Bulletin # SR-5R-1309-02

SAFETY BULLETIN

Ride Manufacturer: Dartron	Affected Production Dates: July 2004 – October 2009
Ride Name: Zero Gravity	Affected Serial #'s: 0404125-5R FORWARD
Model #: All

Abstract of Issue: Early production Dartron Industries, Inc. Zero Gravity amusement rides were produced using a thinner material on the boom drum and boom reinforcement plates. Cracking has been discovered in this area. Testing has determined that ALL Zero Gravities may eventually develop cracking in the same area.

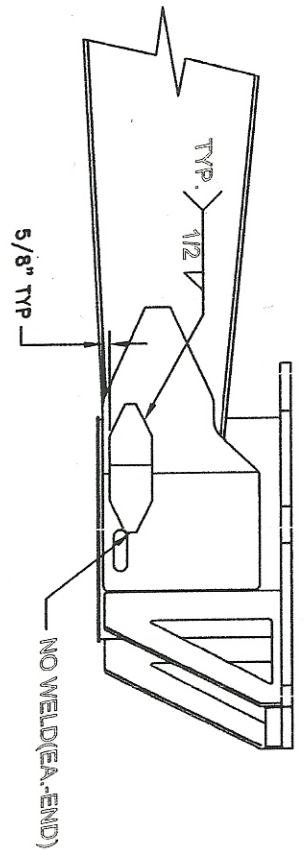
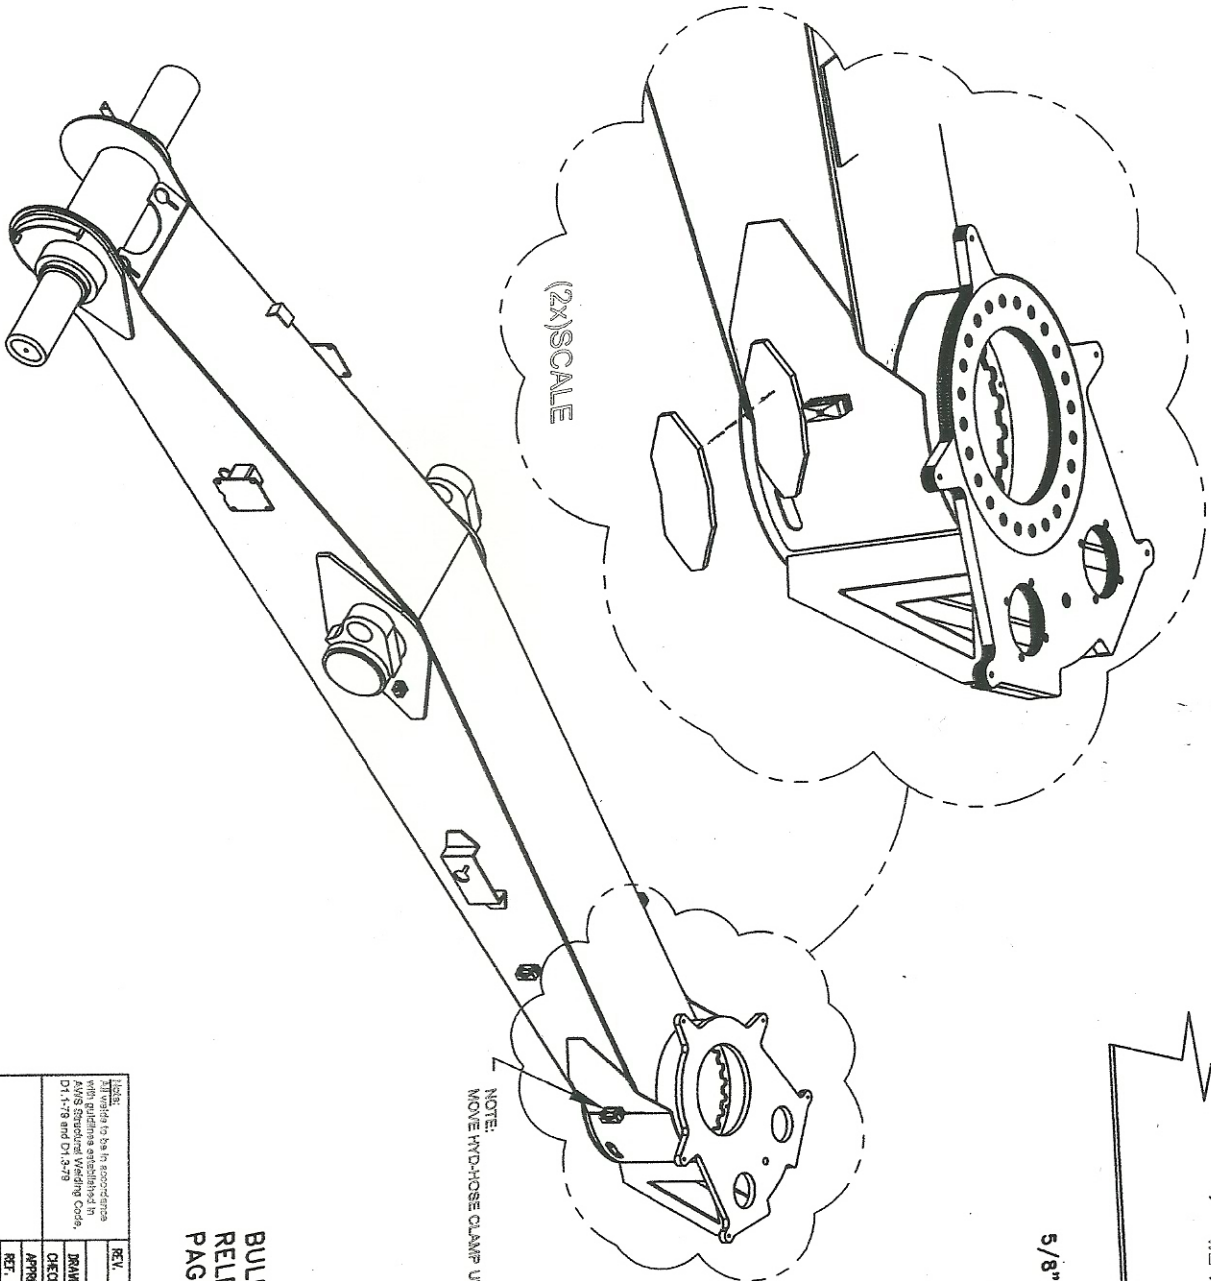
Reason for release: To notify all owners, operators and inspectors of a safety concern with the booms on the Zero Gravity. Subsequent testing has determined that a reinforcement plate is required to insure that this area will not develop cracks at a future time. Failure to add these reinforcement plates may eventually result in the boom drum (bearing base) not adequately supporting the center bearing. A failure in this area could result in injuries.

5. The ground must be connected as close to the weld location as possible to insure that the current does not pass through any bearings
6. Tack securely in place approximately 5/8" from the bottom edge and parallel to it. See the attached illustration on page 4 of this bulletin.

7. Preheat the joint to at least 100 degrees Fahrenheit.
8. Weld the joint with 7018 electrode using DCEP (reverse polarity). Apply stringers in the horizontal and overhead positions. Clean between passes and continue to weld until a 1/2" fillet weld is achieved. **DO NOT WELD THE VERTICAL ENDS.**
